OGRR Comments

| OGRR Number | 208 | OGRR Title | Voltage Ride-Through (VRT) Requirement |

| Date | November 7, 2008 |

| Submitter's Information | |
|-------------------------|--|
| Name | Mark Dreyfus on behalf of the Technical Advisory Committee (TAC) |

Figure 1: Voltage Ride-Through Boundaries For Wind-powered Generation Resources

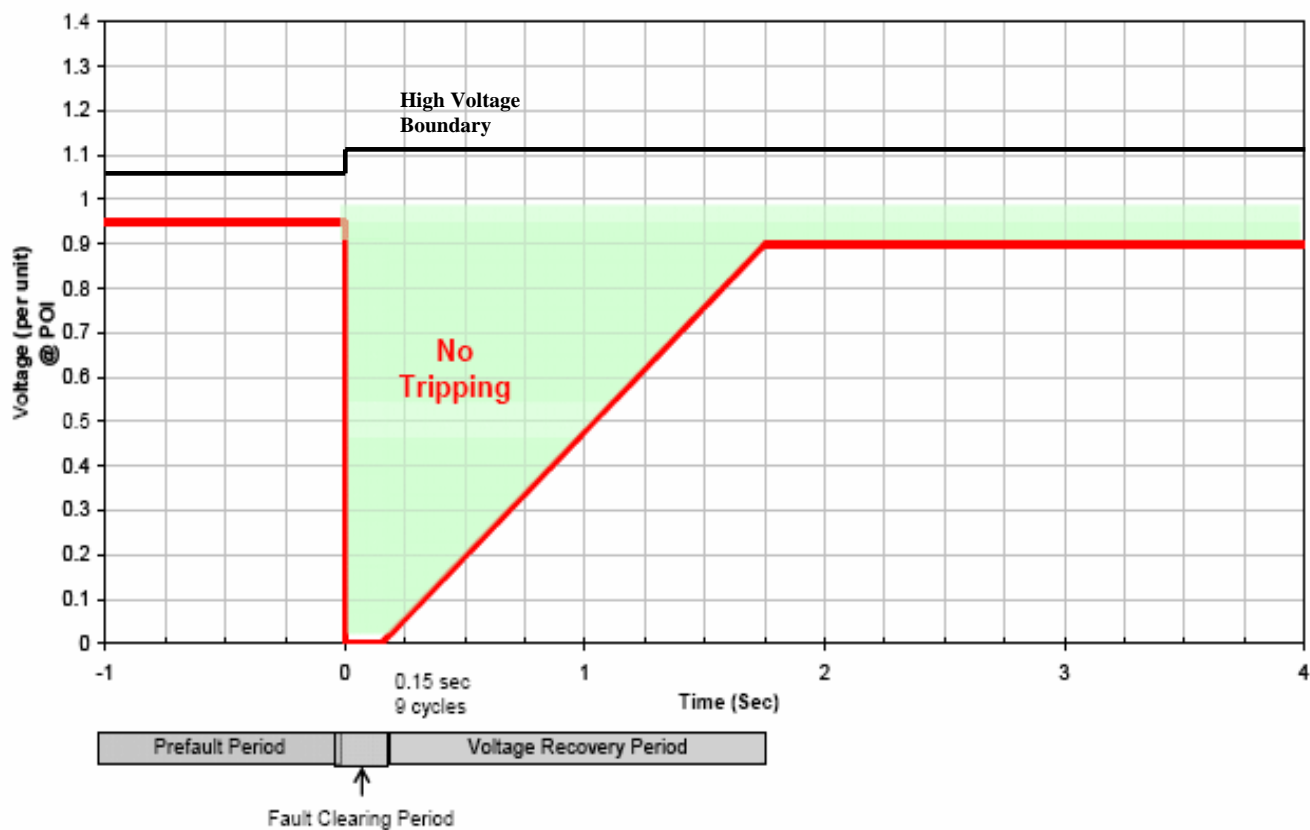
- Wind-powered Generation Resources (WGRs) **specified below** are required to set generator voltage relays to remain in-service during all transmission faults (no more than nine (9) cycles) in accordance with Figure 1, Voltage Ride-Through Boundaries For ~~Generating Units~~, Wind-powered Generation Resources, below. Faults on individual phases with delayed clearing (zone 2) may result in phase voltages outside this boundary but if the phase voltages remain inside this boundary then generator voltage relays are required to be set to remain connected and recover within the voltage recovery boundary of Figure 1.

- -WGR voltage relays shall be set to remain interconnected during three-phase faults on the transmission system for a voltage level as low as zero volts with a duration no more than nine (9) cycles as measured at the point of interconnection as shown in Figure 1. The clearing time requirement for a three-phase fault will be specific to the generating plant point of interconnection, as determined by and documented by the transmission provider in conjunction with the interconnection agreement. This requirement does not apply to faults that would occur between the generator terminals and the transmission voltage side of the generation step-up transformer or when clearing the fault effectively disconnects the generator from the system.

- Existing individual WGRs that are replaced are required to meet the requirements of Figure 1.
- ~~Existing individual WGRs that are part of a Generation Interconnect Agreement signed prior to January 1, 2003 are exempt from the requirements of Section 3.1.4.6.1, Protective Relaying Requirement and Voltage Ride-Through Requirement for Wind-powered Generation Resources.~~

- ~~WGRs that are part of a Generation Interconnect Agreement signed after January 1, 2003 and before November 1, 2008 shall meet the requirements of Section 3.1.4.6.1 by January 1, 2015.~~

- WGRs that are part of a Generation Interconnect Agreement signed after November 1, 2008 shall meet the requirements of Section 3.1.4.6.1, Protective Relaying Requirement and Voltage Ride-Through Requirement for Wind-powered Generation Resources. All such WGRs shall provide a status of compliance to ERCOT System Planning by July 1, 2009.

- WGRs that are part of a Generation Interconnect Agreement signed prior to November 1, 2008 shall provide information requested by ERCOT, including existing WGR VRT capabilities, for a study to evaluate the need for additional protective relaying and VRT requirements applicable to some or all such WGRs. If the results of the study demonstrate the need, this Operating Guide shall be revised to establish those requirements, including a schedule for compliance. ERCOT shall publish study results and provide recommendations to ROS by the scheduled ROS meeting of June 2010
